Your Ref: 2311-38006 SRA  
Our Ref: F22/31  
MSC Ref: MCU/23/0012

**RE: RESPONSE TO SARA INFORMATION REQUEST**  
**APPLICATION FOR A MATERIAL CHANGE OF USE – EDUCATIONAL ESTABLISHMENT**  
**LOT 71 ON SP292140, 267 MCIVER ROAD AND CHEWKO ROAD, MAREEBA.**  
**DEVELOPMENT APPLICATION MCU/23/0012.**

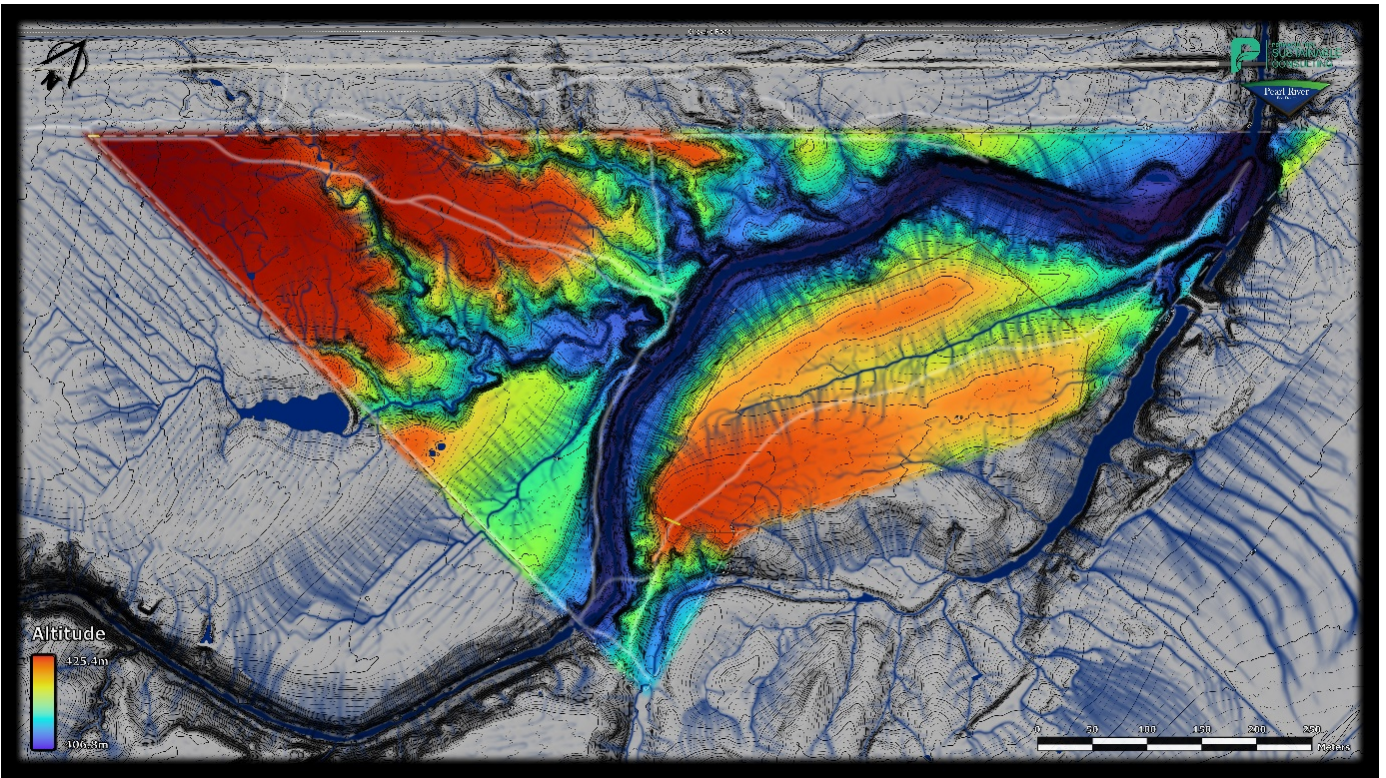
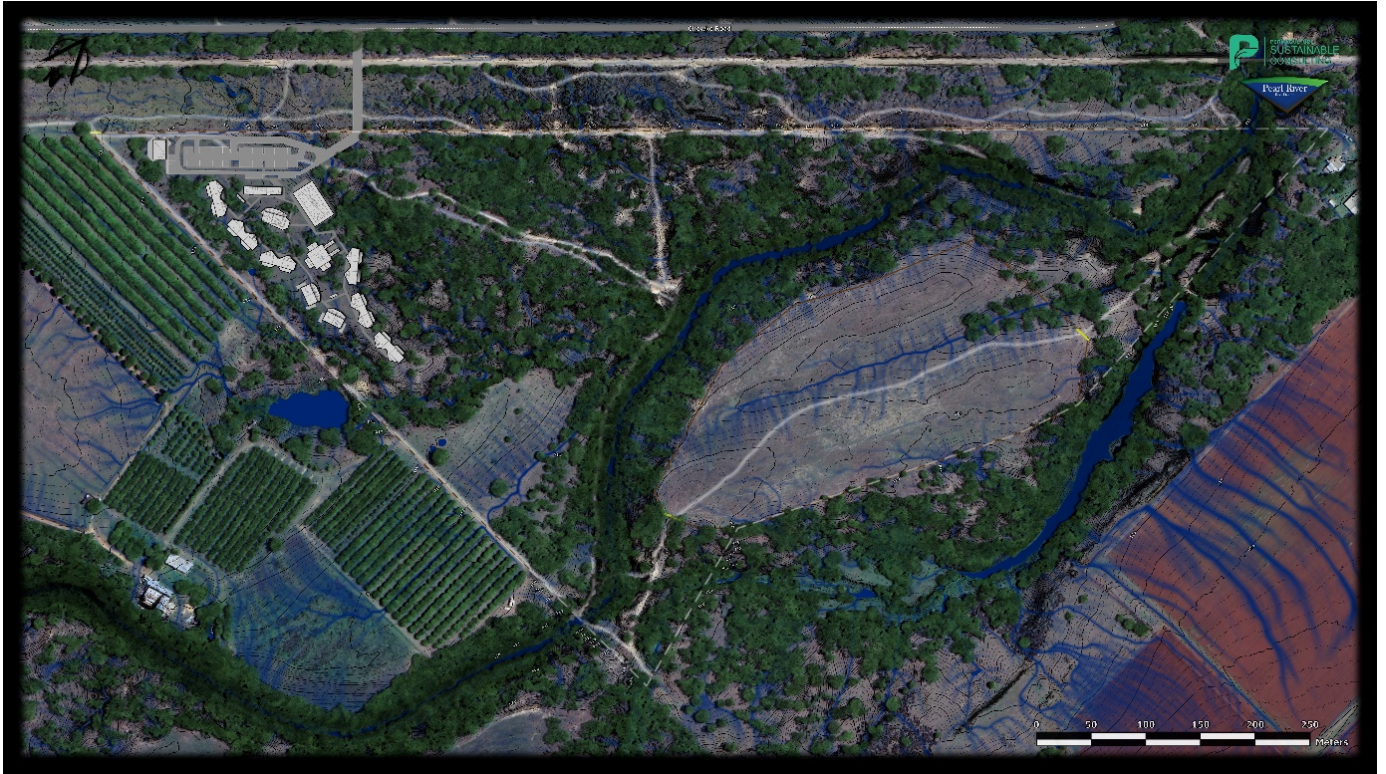
*The referral material has not included adequate information to demonstrate that the stormwater impacts of the proposed development will not adversely impact on the railway corridor. In particular, the site appears to both discharge towards the railway corridor and accept stormwater from the railway corridor. The development will increase the impervious area on the site and may therefore alter stormwater impacts in the railway corridor.*

*The Stormwater Management Plan should demonstrate that the management of stormwater post development can achieve a no worsening impact (on the pre-development condition) for all flood and stormwater events that exist prior to development and up to a 1% Annual Exceedance Probability (AEP). This should include at least the following flood and stormwater events: 63.2%, 50%, 20%, 10%, 5%, 2% and 1% AEP. Stormwater management for the proposed development must ensure no worsening or actionable nuisance to the railway corridor, including rail transport infrastructure, caused by peak*

*(i) Pre-development condition. Provide information to verify the existing drainage characteristics of the site, particularly in relation to the railway corridor. All legal points of discharge for the development site should be identified.*

*(ii) Earthworks Plan. Provide a concept earthworks plan, including cross sections/elevations, and any required supporting technical details clearly showing the location and extent of proposed excavation and filling (earthworks). The difference between existing site levels and finished/design levels should be clearly shown.*

*(iii) Catchment Analysis. Provide pre-development and post-development catchment plans that clearly identify all internal catchments on the site, external catchments draining into the site, the flow paths (direction of flow) within each catchment, the size of each catchment and the legal point of discharge for each catchment.*

The Project Manager in conjunction with the Developers have gained LiDAR mapping for the site and provide below for your records. The first image shows the satellite image with the proposed builds and the second image shows the altitude of the property.

These images show us the Pre-construction state of the property that;

1. The proposed construction is contained on the highest part of the property based on the below LiDAR Maps.
2. The natural levels of the land are highest where the development is proposed and have fall towards the creek.

infrastructure. It is not considered that there will be any significant additional Stormwater Impacts to the Railway Corridor with the proposal. The Lidar Imagery clearly demonstrates that natural flows, features, and drainage over the property which is directed away from the Railway Corridor.
